# FCSD Field Service Action 21P08

## DEALER NOTIFIED SERVICE PROGRAM

**Subject: 21P08 - Endura - 2.0L EcoBlue (Panther) EGR Mesh Filter Blockage**

**FIGURE 1**

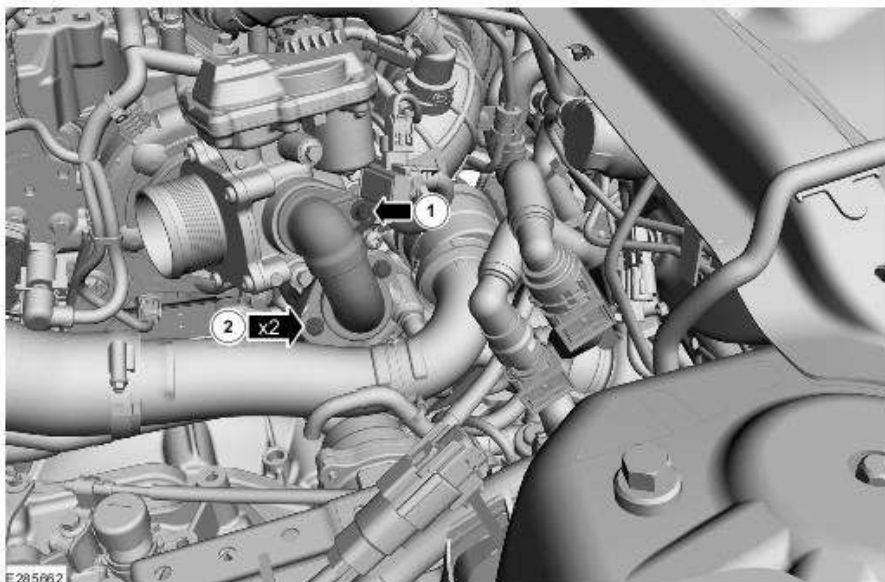
1. Remove the EGR cooler to EGR valve tube. Please refer to the Workshop Manual Section 303-08. See Figure 1.

**FIGURE 2**

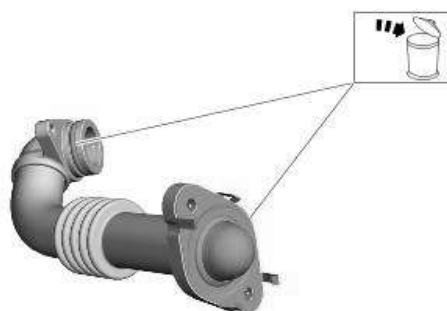
2. Remove and discard the gasket and O-ring. See Figure 2.

**NOTE:** Install new gasket / O-ring.
